## **REMARKS**

### **Objection to the Specification/Drawings**

### **35 U.S.C. § 102(e)**

**FIG. 5**

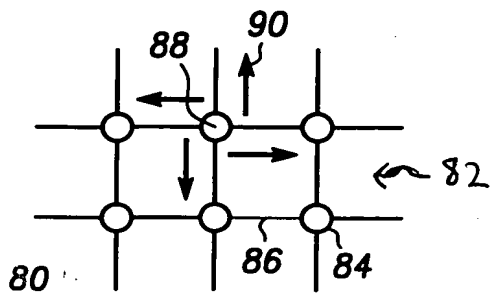
The specification was objected to because on page 10, line 10 of the specification, the term "fabric 82" was not shown in FIG.5. A marked up version of FIG.5 is included with "82" added to indicate "fabric" per the specification. To expedite prosecution, formal drawings are being submitted along with this amendment.
